TAC No. MA5085 (NMPI)

I have recently read your report "Safety Evaluation by the Office of Nuclear Regulatory Regulation Related to Extension of the Schedule for Reinspecting Core Shroud Vertical Welds Niagara Mohawk Power Corporation Nine Mile Point Nuclear Station, Unit 1" (Docket No. 50-220) issued 2 November 1998. I have also reviewed the studies issues by Niagara Mohawk Power Corporation (NMPC) which were submitted to the NRC to justify the operating extension authorized in the safety evaluation (SE). I am writing to alert you to several serious errors in the NMPC studies — errors which undermine the conclusions of the NMPC and the NRC that the crack growth rate may be safely assumed to be below  $2.2 \times 10^{-5}$  inches/hour. The most egregious errors were in the data analysis of the sensitization (EPR) measurements. The researchers who performed that measurement have not followed the scientific method and as a result have significantly overstated of the accuracy of their results. Once properly analyzed, the sensitization data does not infer the lower crack growth rate nor does it rule out irradiation assisted stress corrosion cracking (IASCC) as the cracking mechanism.

Figure 1: Corrected EPR Data Using Altran Conversion Method

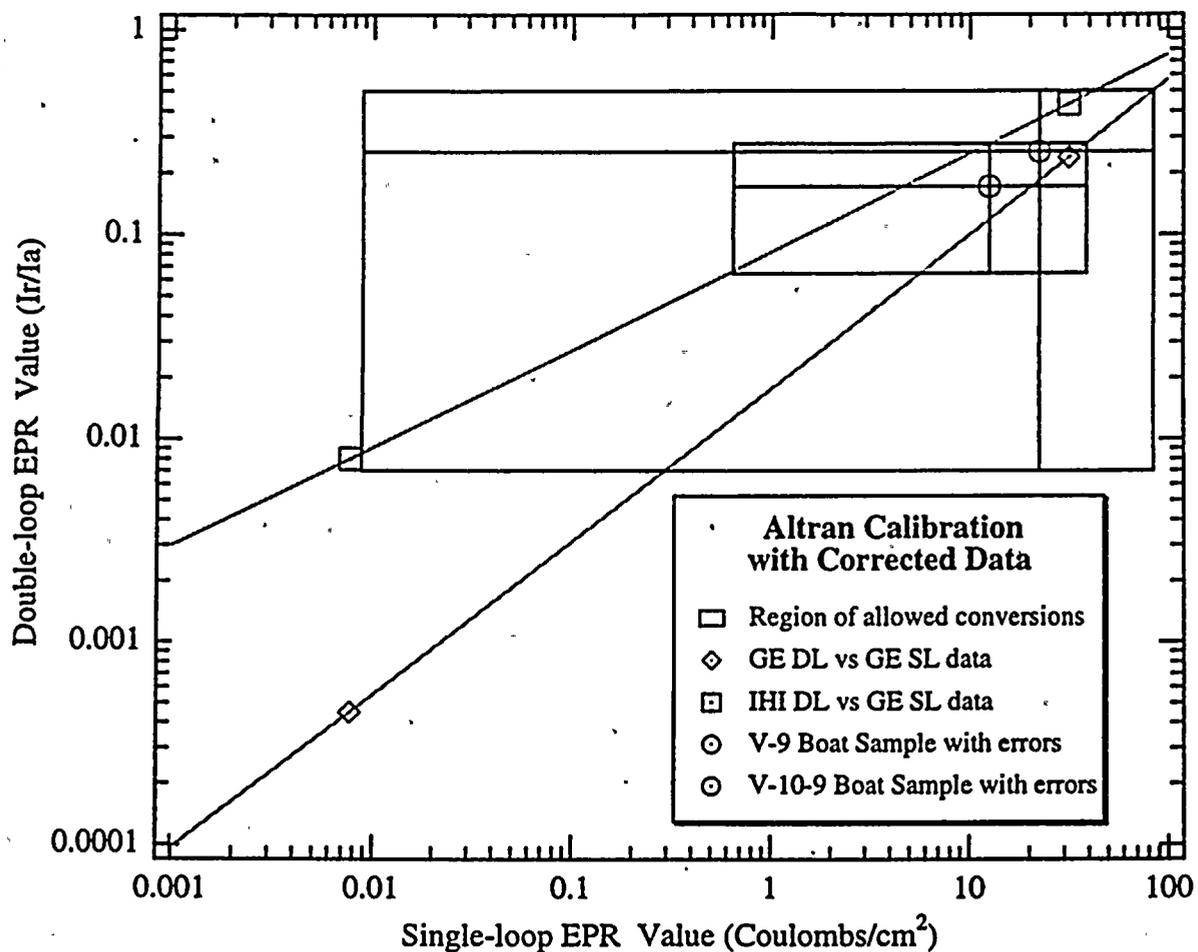
Following equations [1] and [2] and given that the SL and DL values are related by a power law, we plot the data from Table 2 on a log-log plot (Figure 1). The shaded region is the range of conversion factors. The limiting curves are described by the conversion formulae:

I have also plotted the corrected McDermott DL results (see table 1) for boat samples V-9 and V-10 with their error bars. The conversion limits establish the range of SL error. This range may also found using equations [3] and [4]. The converted SL data for the boat samples is listed in Table 3.

Therefore, we find that when we correctly analyze the data and propagate the errors the results of the EPR measurements are more than a factor 2 greater than those listed in the Altran report and cited by NMPC. These SL results are also approximately proportional to the relative fluence at these locations. However, it is hard to draw any definitive conclusions since the error bars are quite large.

Figure 2: McDermott EPR data with Altran Conversion Method

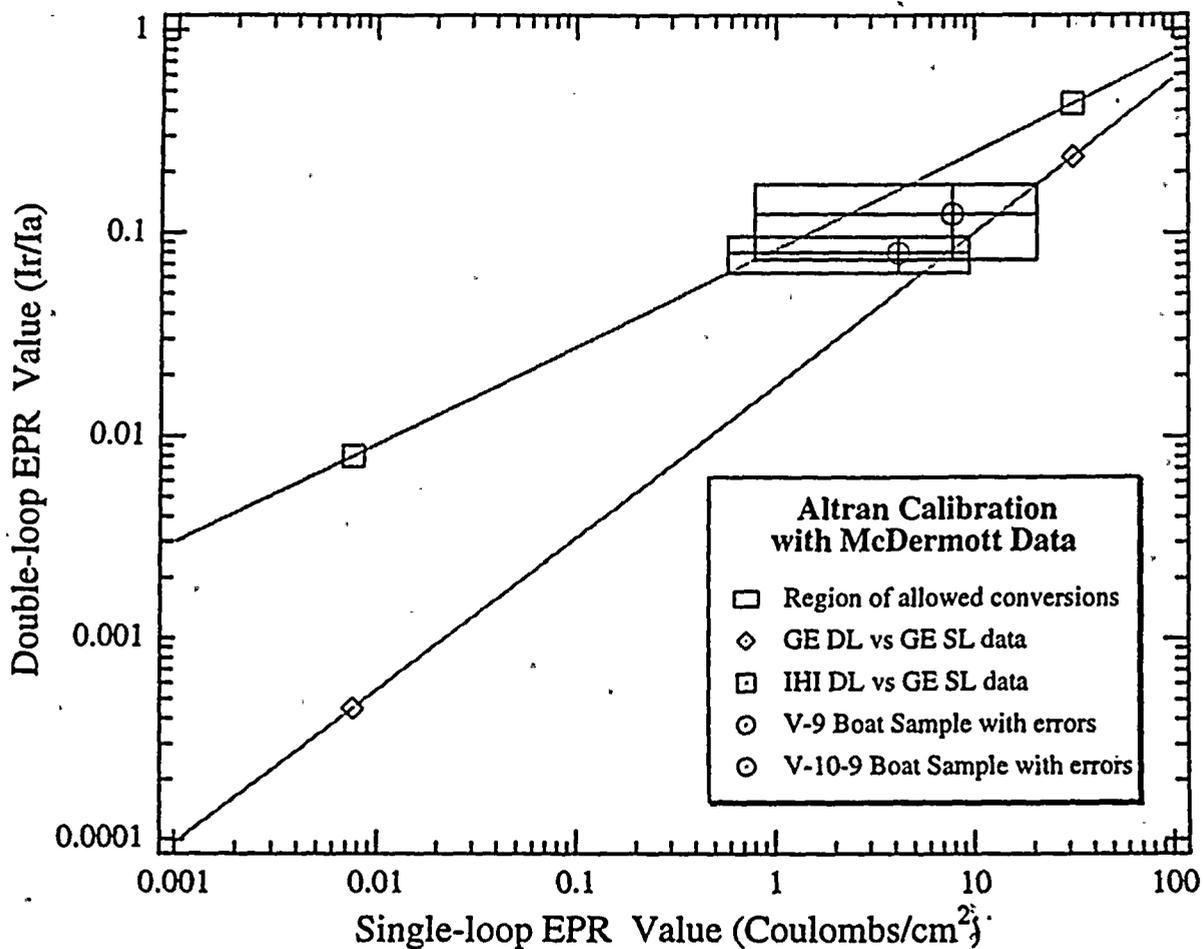
Finally I will note that even if we restrict ourselves to using DL data which the McDermott Corp. researchers labeled as legitimate; the appropriate error bars should have been presented. In Figure 2 I have correctly plotted that data with errors. The McDermott DL results for V-9 and V-10 are listed in Table 1 of appendix 2 of the Altran report. Note that the data for Run #4 on V-10 was not reproduced in this table. There was no mention why that data was excluded. Oddly the data for Run #5, which was noted to have a problem because *IR* was negative, was included. I reproduce McDermott's data with error in Table 4. The single-loop results are presented in table 5.

Figure 3: Weld V-9 Crack Profile overlaid with Fluence Profile along V-9

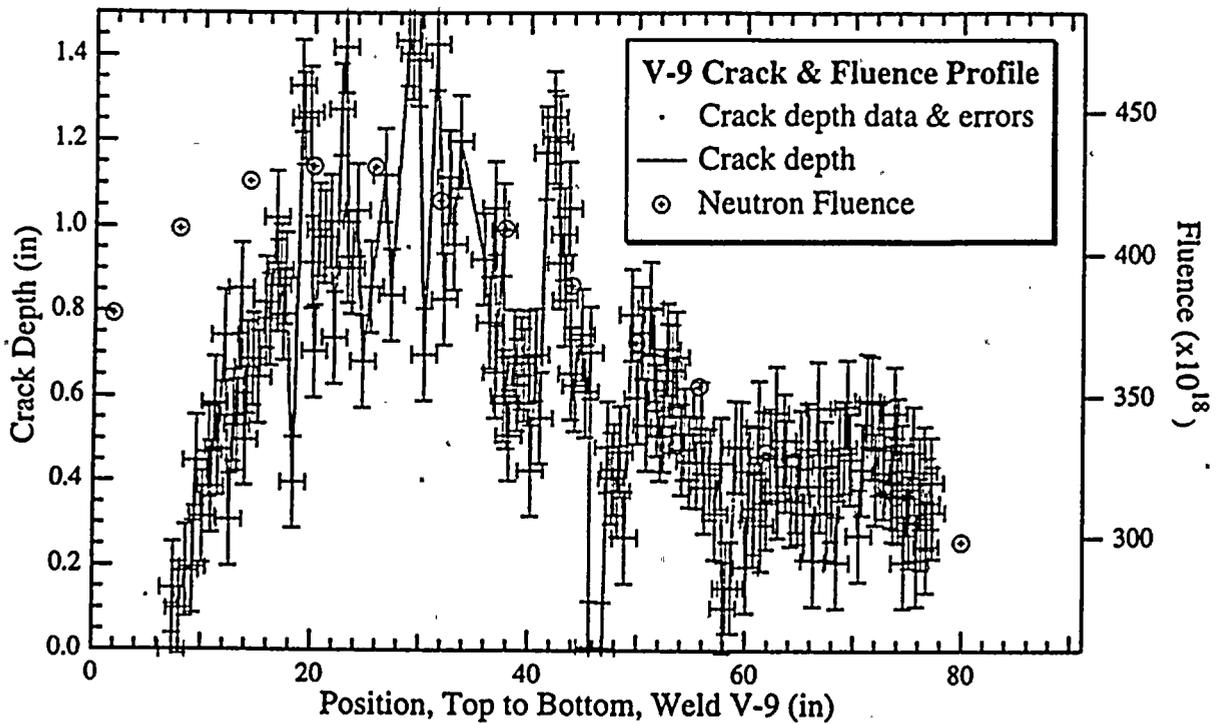
The best indication of the contribution of fluence to the crack growth rate is to make a direct comparison — to compare the fluence profile with the total "effective" crack depth profile for each weld. In Figure 4 I overlaid the fluence predictions and the crack depth profiles, both taken from the NRC SE. When studying this graph we should bear in mind that the point-to-point fluctuation is largely due to the measurement error. For V-9 we see that the fluence profile and the crack depth profile are well correlated suggesting a causal relationship. For V-10 we do not have a true effective crack depth profile, as explained above. However, noting this limitation, we may still compare the fluence profile with the depth profile for the crack to the right of V-10. In this case we also see significant correlation though not to the same extent as witnessed in V-9. Taken together, these correlations suggest that the fluence is a significant driving force behind the vertical weld cracking. On the final page of the 2 November 1998 SE, the NRC noted the correlation between the fluence profile and the V-9 crack profile. The NRC should have taken the fluence profile and the crack depth data, with errors, and performed a weighted correlation calculation. A significant correlation would have indicated a causal relationship between the fluence and the vertical weld cracking.
